NAVAL BIODYNAMICS LABORATORY  
NBDL-91R003

## HUMAN FACTORS ASSESSMENT OF USCG 47-FT MOTOR LIFEBOAT

Technical Report

## **I: Preliminary Evaluation of Ergonomic and Safety Deficiencies**

Figure II.8. Proposed footrest on open bridge starboard steering station.

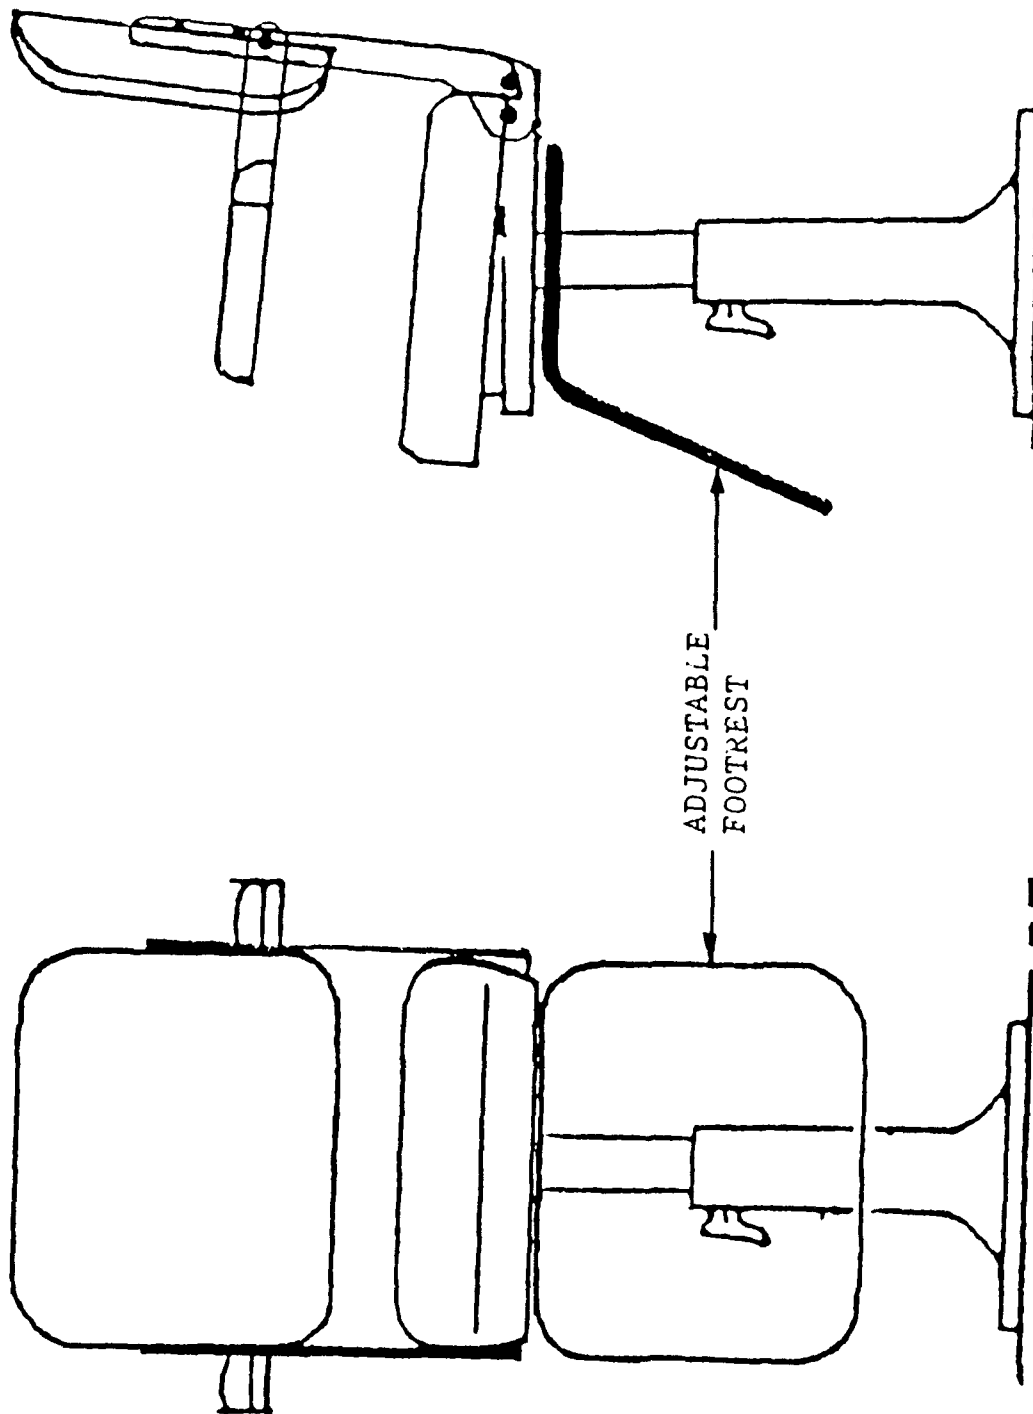
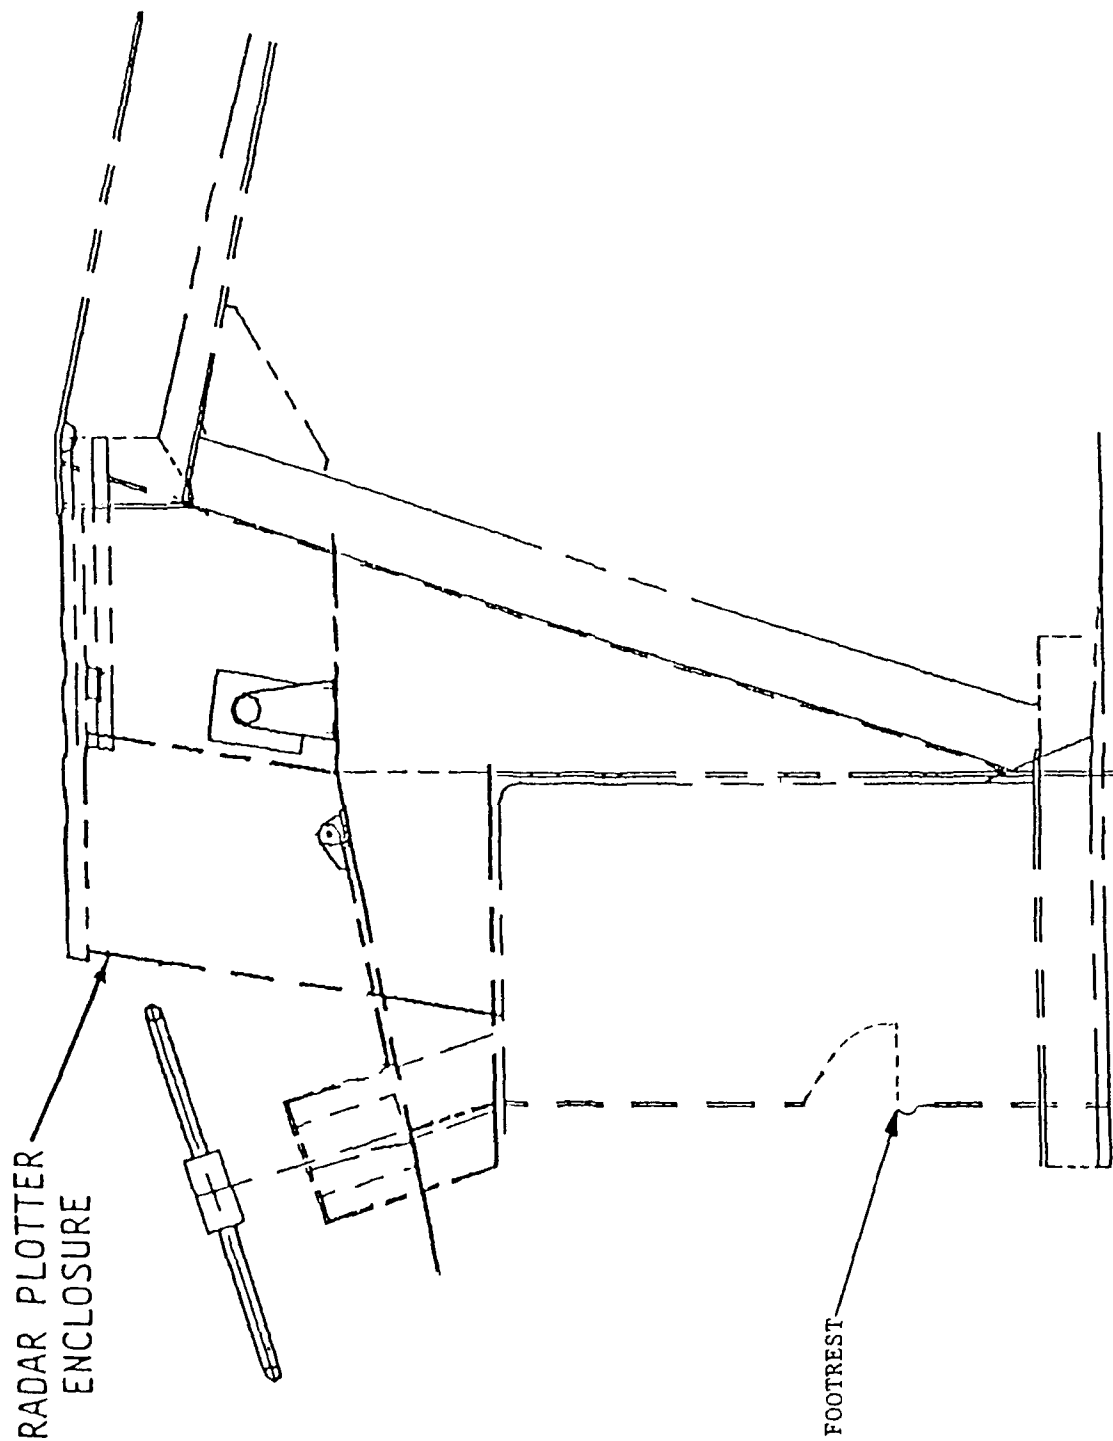
- Footrests are required in order for crew personnel to brace themselves during rough sea conditions; footrests would increase the safety of the crewmembers in the open bridge as well as maintain basic foot-to-seat height relationship. In rough seas, the operator is forced to hold onto the chair or the steering station in a fixed position for long periods of time without rest. Providing footrests would help decrease overall fatigue. Figures II.7 and II.8 propose two approaches to providing footrests at the steering station. Figure II.7 illustrates a footrest bar extending from the chair to an optimal height and length. Footrests should maintain a desirable foot-to-seat height relationship from the pan of the chair (approximately 16-20 inches). Figure II.8 shows a side view of the starboard open bridge steering station with the proposed footrest located directly below the console or where the current access panel is located. The proposed footrests should be approximately 1/2 shoe length (4 to 6 inches). The proposed footrests would also apply to the open bridge port steering station.

**Figure II.9.** Chair with "wraparound" backrest and adjustable armrest.

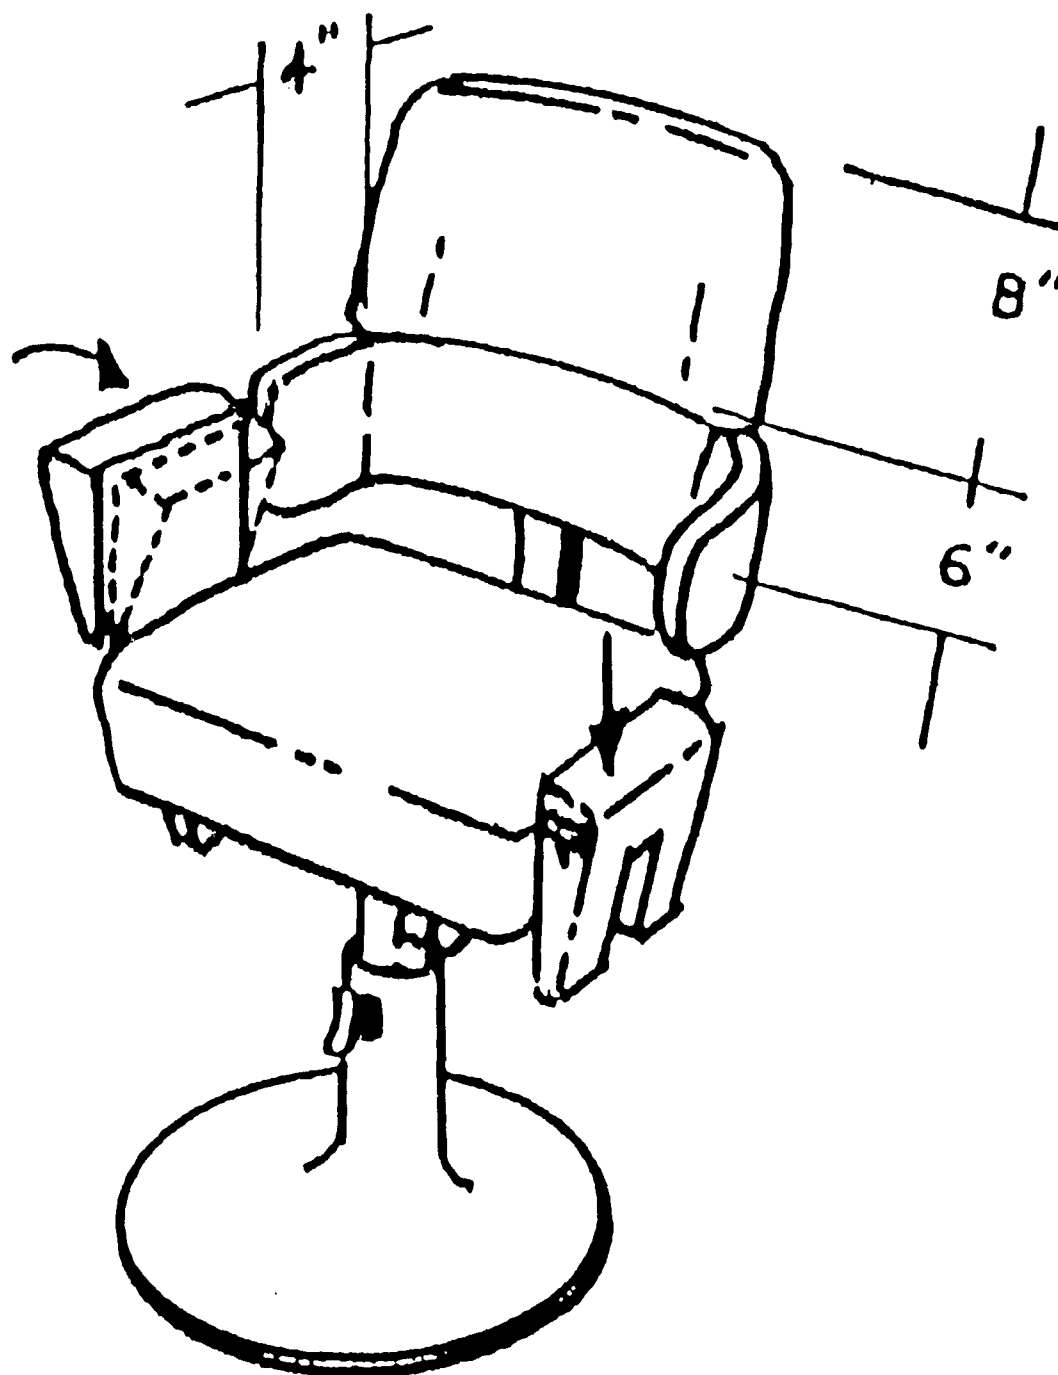
- Armrests can be designed to tilt inward to serve as a semi-restraint system for the chairs in both the open and closed bridges. The addition of a "wraparound" section to the backrest also helps secure the occupant against lateral movement/forces. Adjustment controls should always be designed and located so that the operator can use them easily, but the controls should not get in the way and cause crew injury (see Figure II.9).

**Figure II.11.** Wide angle view of enclosed bridge.

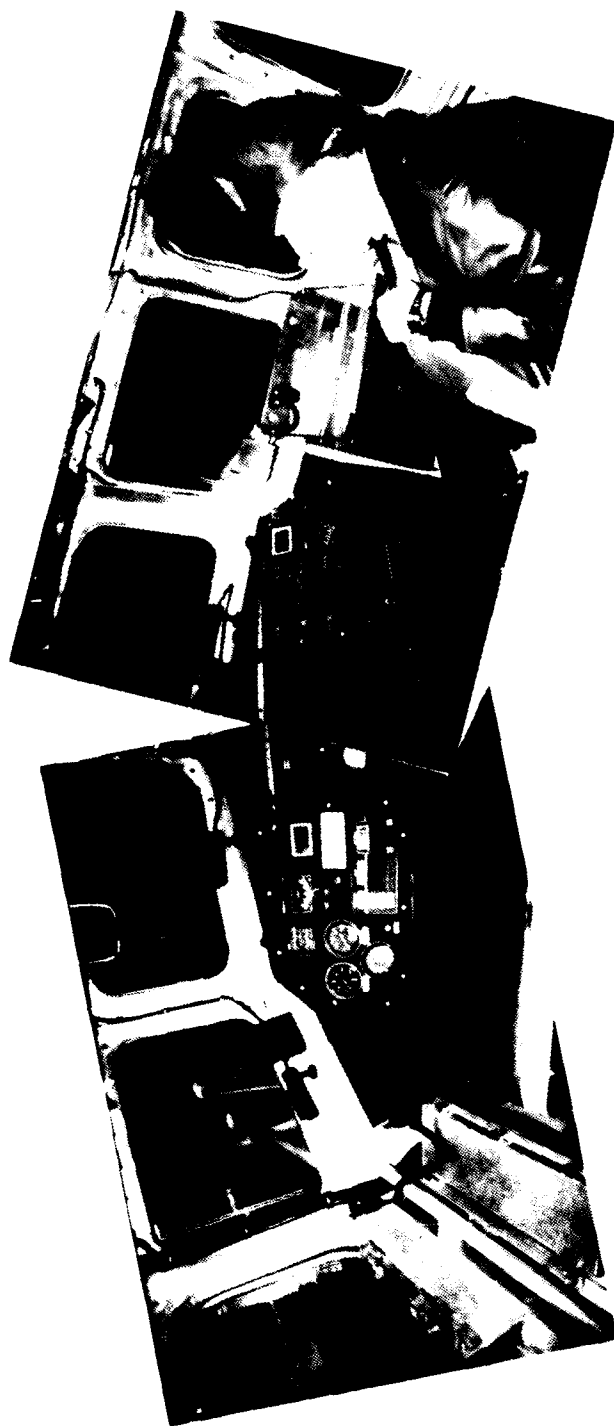
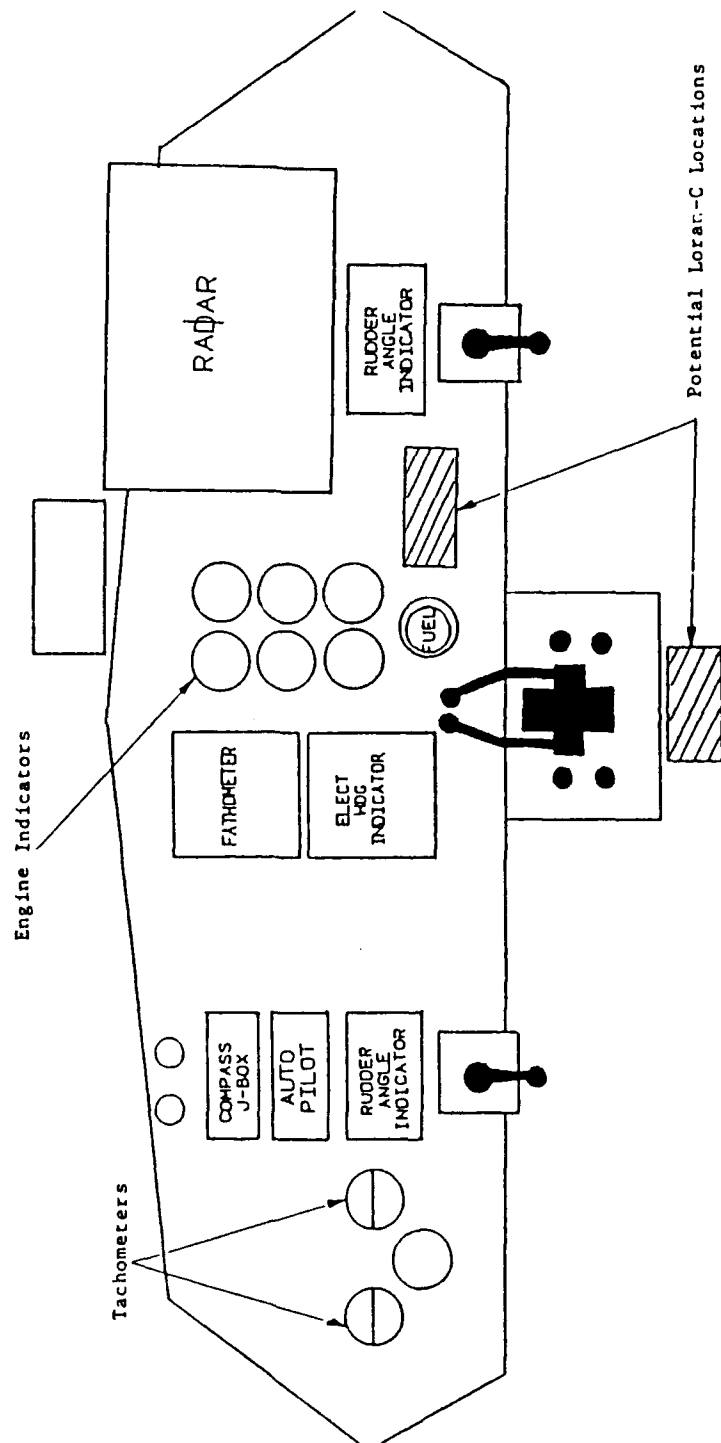
The appearance of the steering stations seems to indicate that the existing layout of controls and displays was based primarily on space considerations, placing equipment where it would fit (see Figure II.11). A more organized arrangement is possible. However, the current layout due to the constraints of the boat may not follow optimal human factors engineering fundamental guidelines, but should be adequate.

- Relocate controls and displays from the center console to the dashboard or overhead. The center console would be eliminated from the current enclosed bridge configuration. In this configuration the throttle control is mounted on a centerline panel, allowing both operators free movement to enter and exit their chairs (see Figure II.12). The Loran-C may be relocated to the aft side of the centerline panel and accessible to both operators. Another possible location for the Loran-C would be in a position under the proposed centerline mount.
- Relocate outboard port and starboard electrical panels (see Figures II.13 and II.14) to a watertight compartment accessible to the engineering crew. It is recommended that the panels be relocated

Figure II.16. Proposed enclosed bridge with two sets of jog levers and throttles.

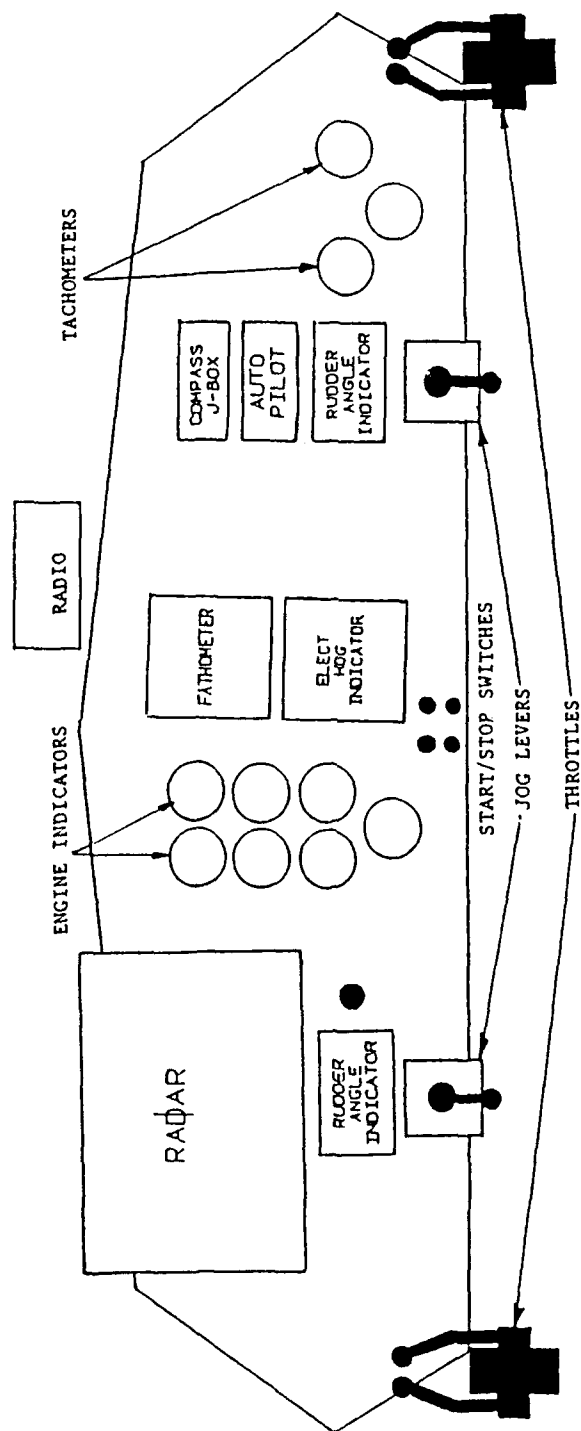
- Figure II.16 illustrates a layout that utilizes two sets of jog levers and throttles, increasing the ability to maneuver the boat from the enclosed bridge. In this configuration the primary steering station is located starboard and the navigation station is located port.

- All throttle controls should be designed to include throttle lock-out control or control cover to safeguard against inadvertent control manipulation. Controls without lock-outs are engaged at all times and inadvertent operation could be dangerous in close-in maneuvering, as the operator may not be able to regain control of the boat from unexpected throttle movement.

Figure II.19. Proposed relocation of radar plotter.

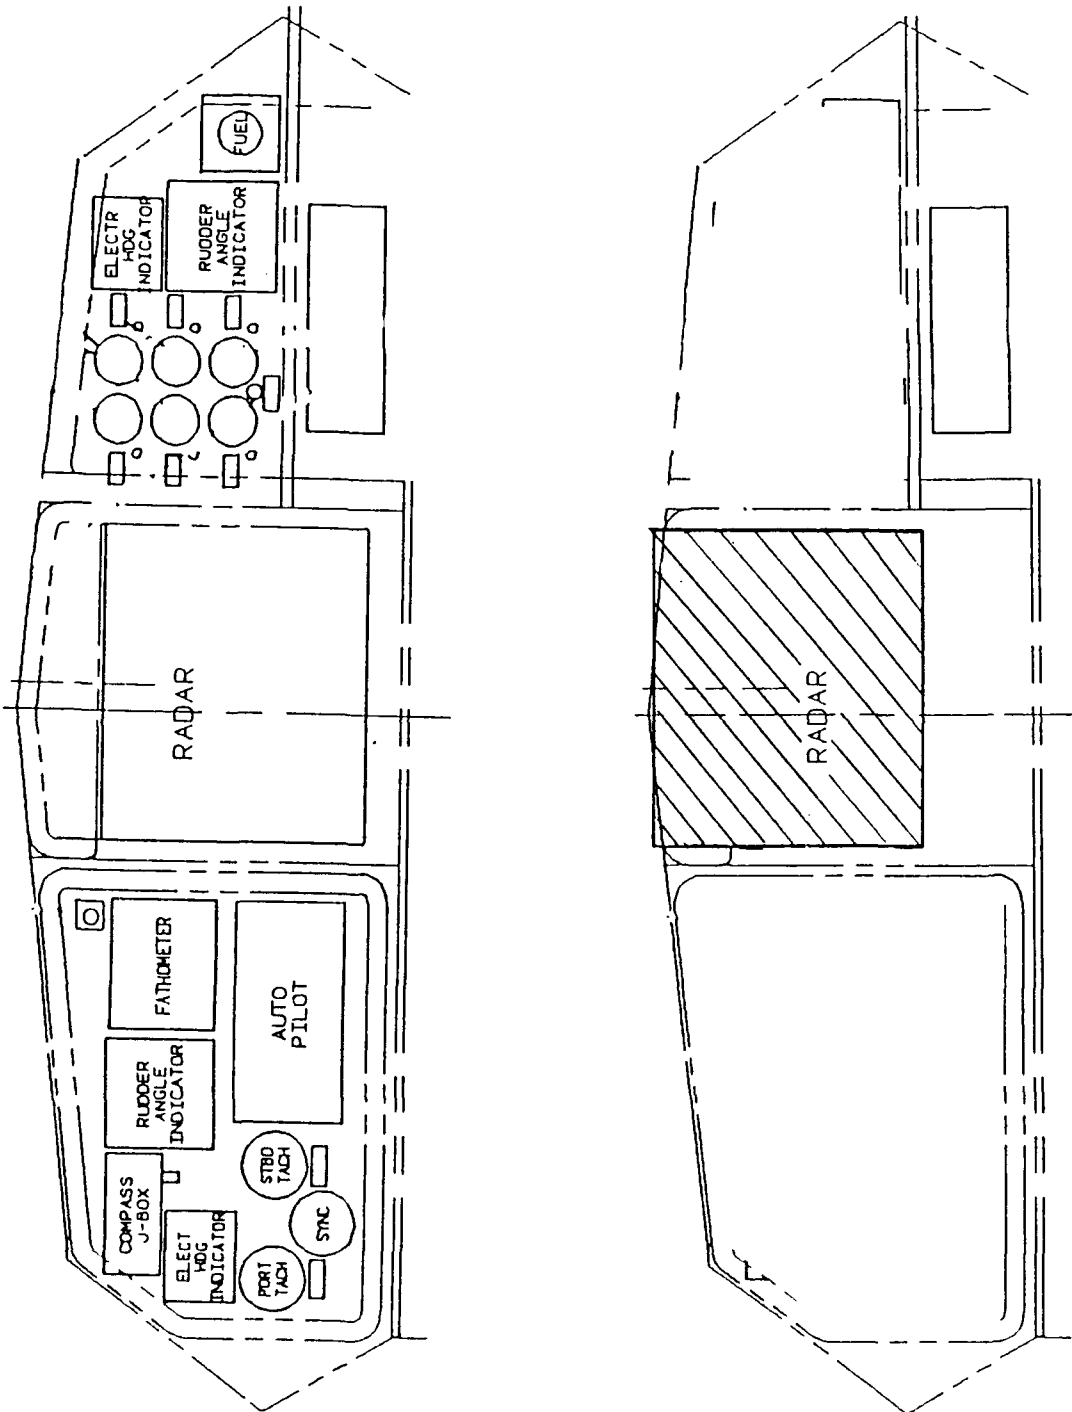
- Problem:**
- Radar plotter screen: The radar plotter is located between the port and starboard dashboards. The radar plotter is visible and accessible to both operator positions (see Figure II.18).

- Approach:**
- Relocate the radar plotter screen to a higher position on the dashboard (see Figure II.19). In addition, the angle/inclination of the screen should approximate 105°. The radar plotter keyboard functions as a duplicate of the controls on the radar plotter. The keyboard is not essential to the operator of the screen and should be eliminated.

Figure II.20. Wet compass and window wiper controls.

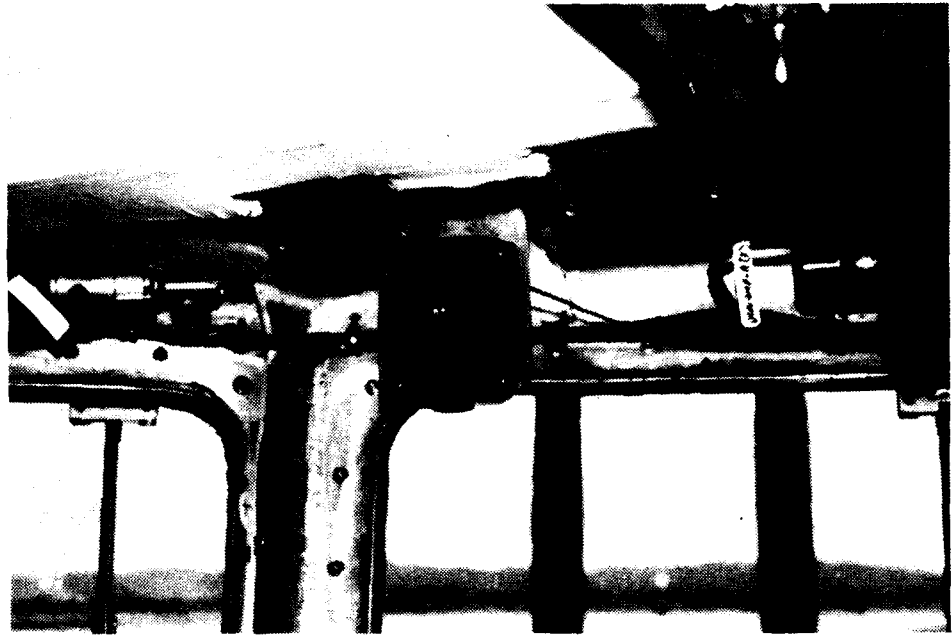
- Arrange the gauges in a similar manner in both open and enclosed bridges (see Figures II.5 and II.12).
  - Wet compass in the enclosed bridge: This compass is attached to the overhead above the port operator's position (see Figure II.20). Normally, to steer a heading, one lines up the compass lubber line with the desired course degree heading of the compass. The helmsman and lubber line are normally in parallel alignment with the boat's longitudinal axis.
